ADMINISTRATIVE AMENDMENT NOTICE

Petitioner #:2014-002

The amendment seeks a change to the approved Rezoning Petition to *modify the approved site layout*, in accordance with Chapter 6 Section 6.207 of the City of Charlotte Zoning Ordinance.

SUBJECT: Administrative Approval for Petition No. 2014-002 The Rainier Group, LLC

RZ1.0

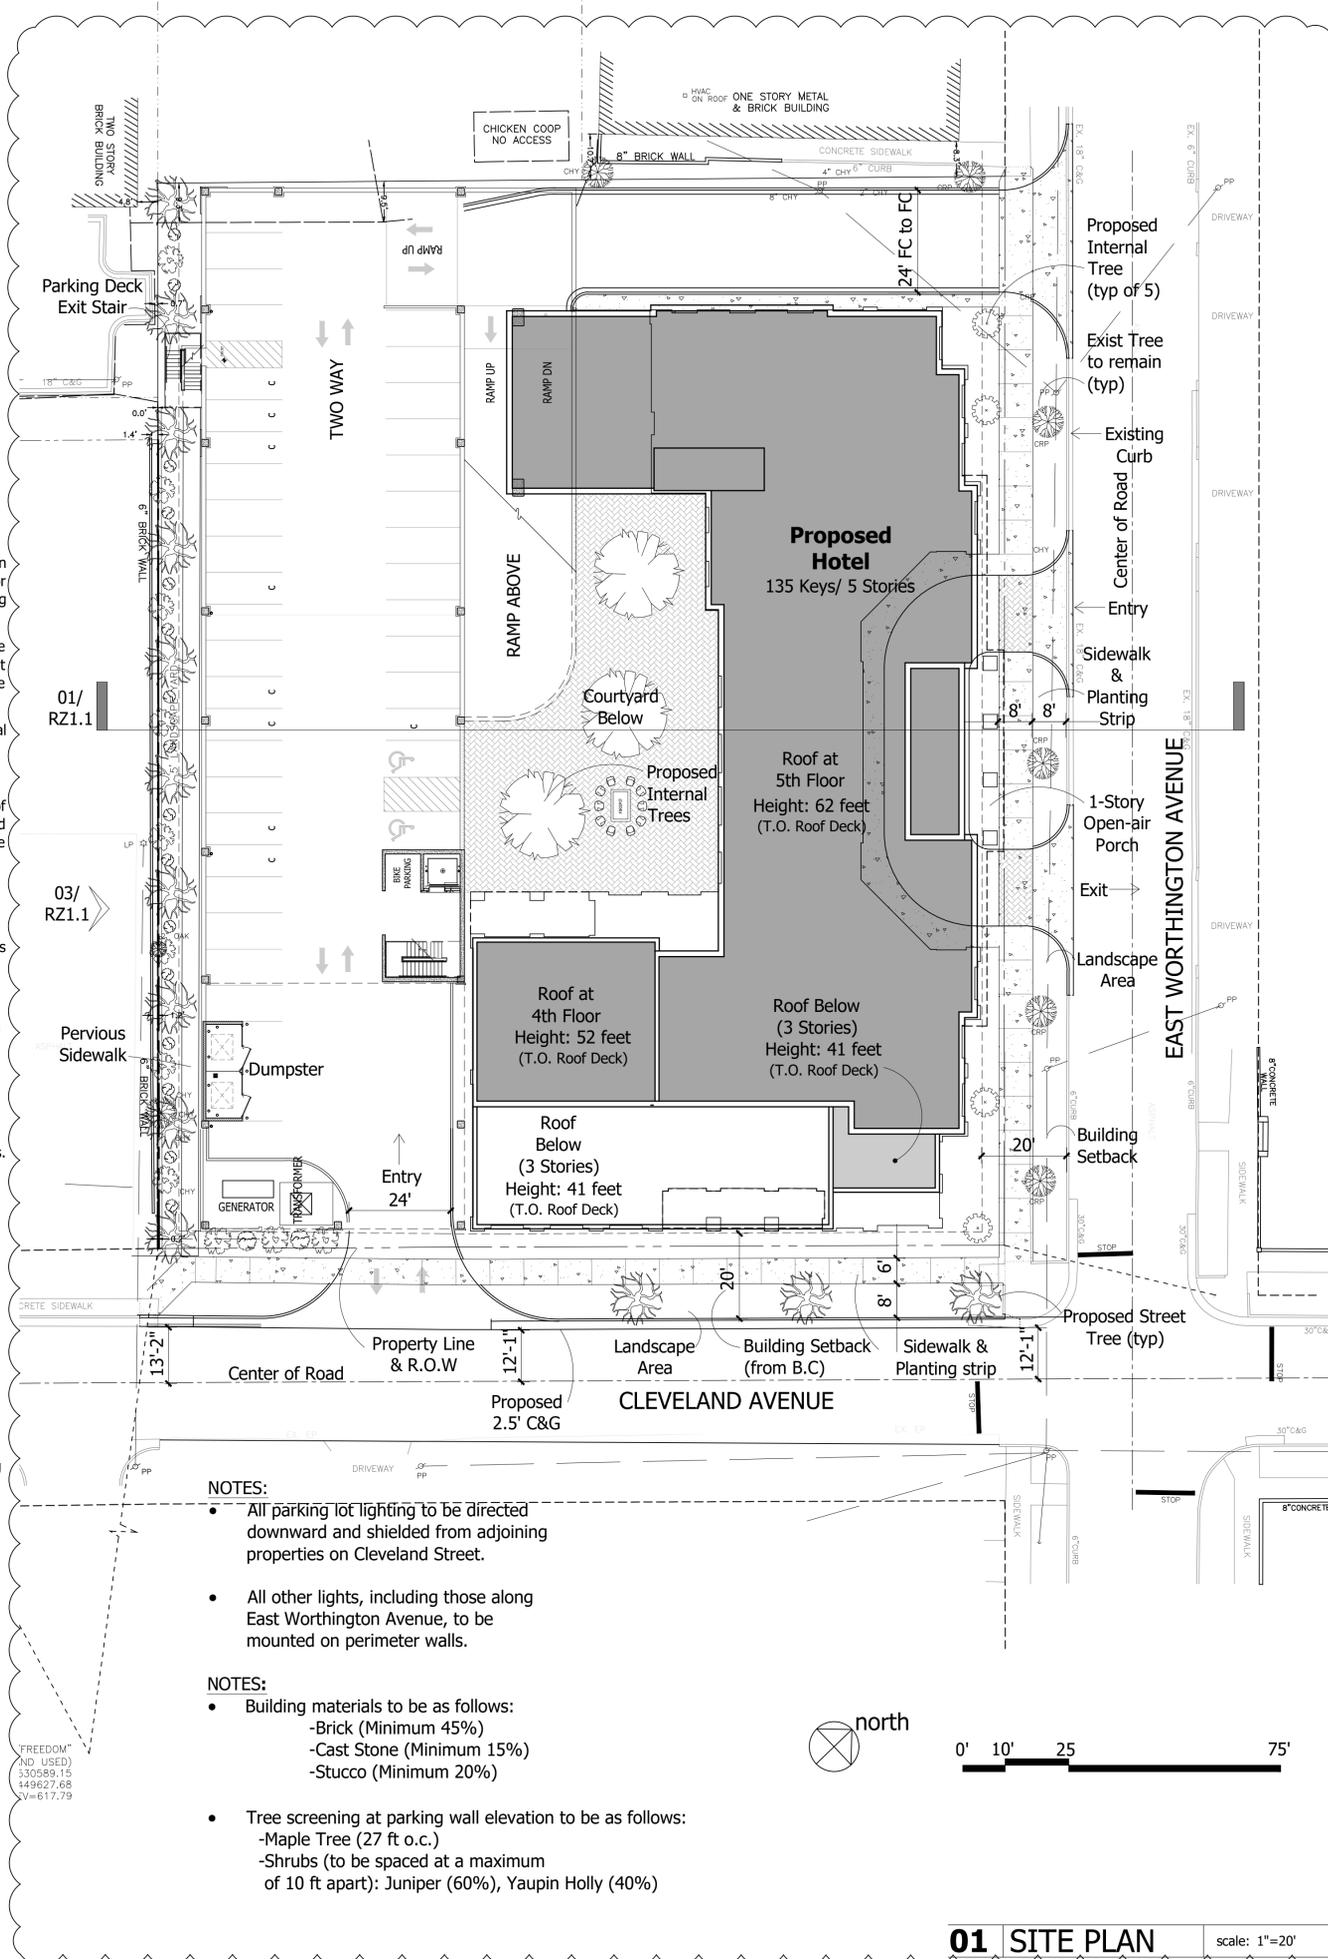
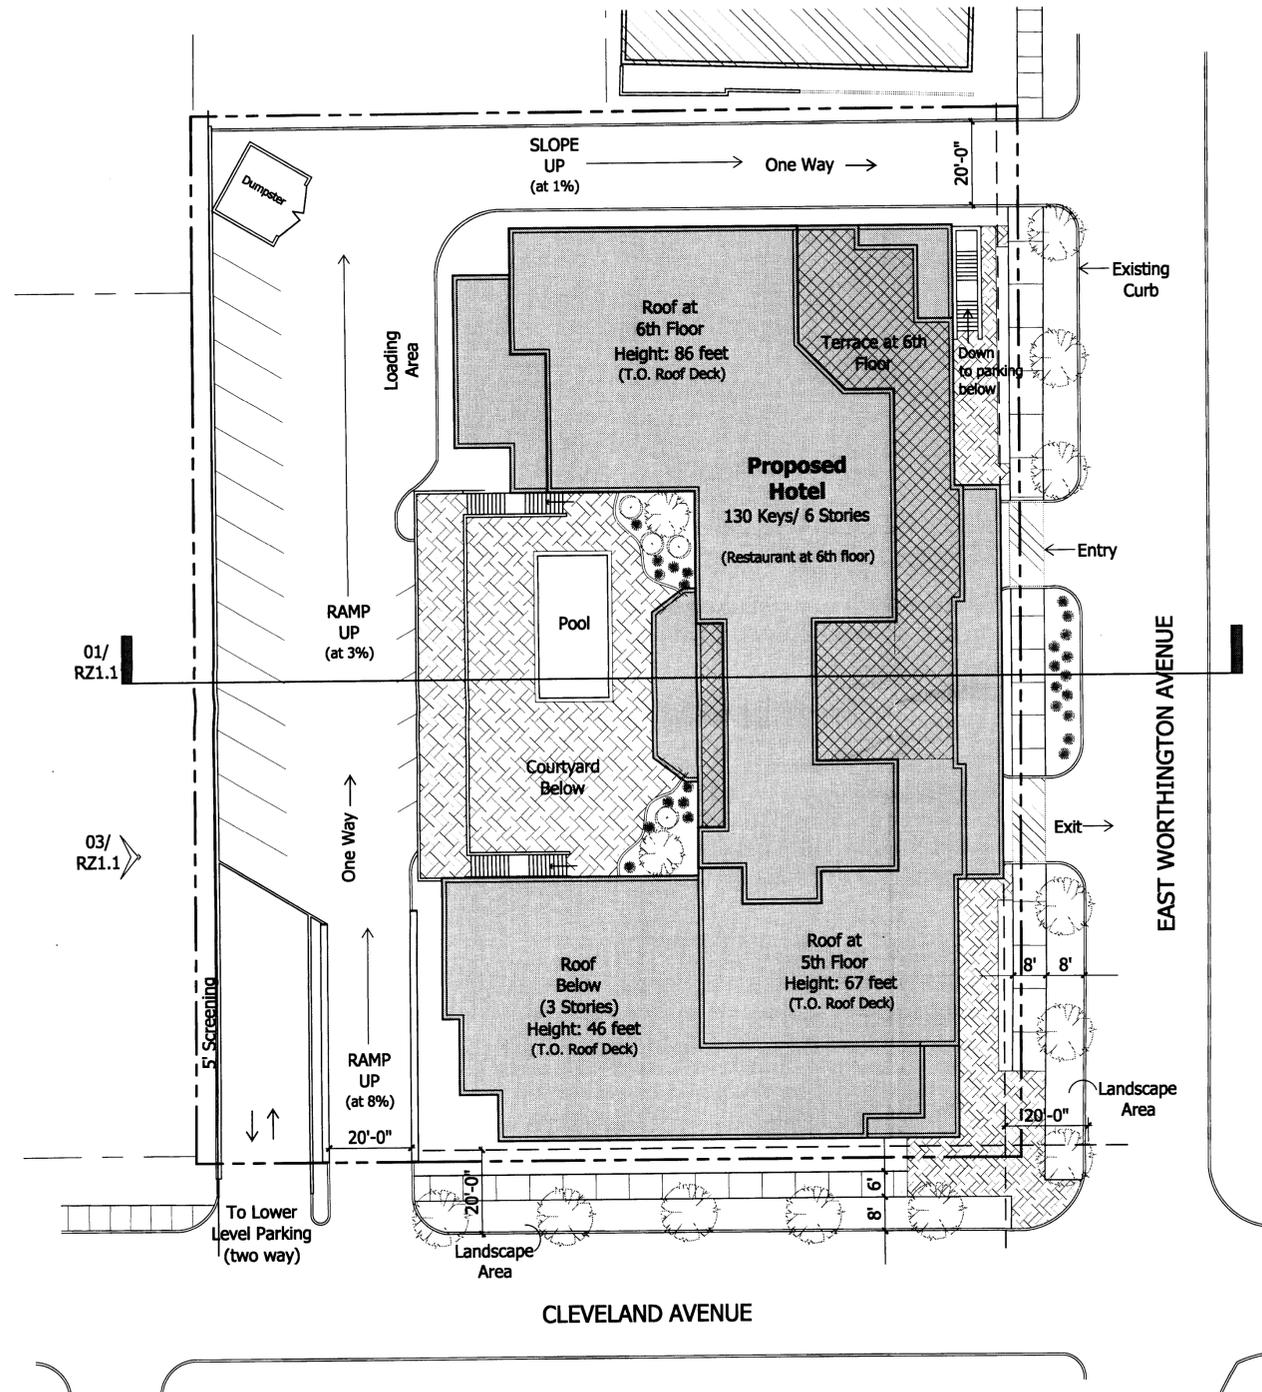
- Allows an increase of 5 five hotel rooms per section 6.207 for an overall total of 135 rooms.
- Modification to the proposed building elevations.

The purpose of this Rezoning application is to provide for the development of a tract of land included in the South End Transit Station Area Plan generally at the corner of Worthington Avenue and Cleveland Avenue. This development will provide the location for a hotel with up to 135 rooms along with customary compatible and ancillary uses and customarily incidental accessory uses and parking as more specifically defined below in the Permitted Use section. To achieve this purpose, the application seeks to rezone the site from the current TOD-R (CD) zoning to TOD-M-O.

RZ1.1

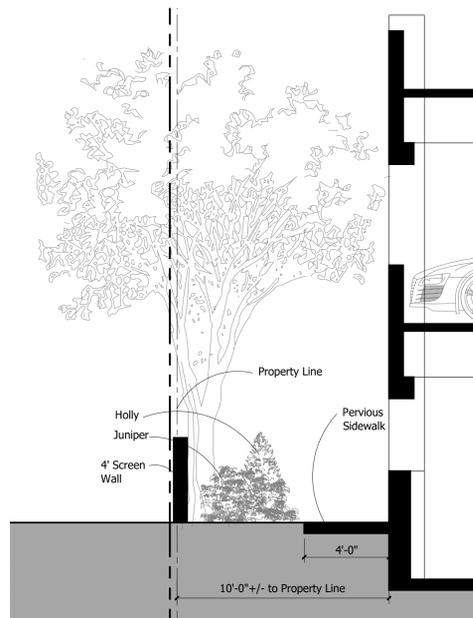
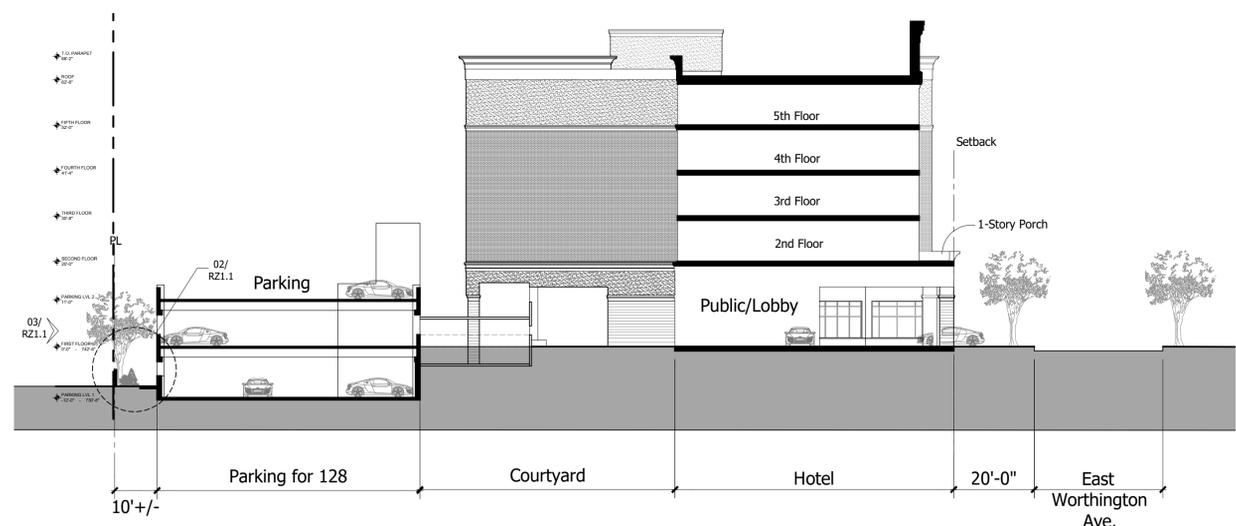
ENTIRE SHEET REVISED
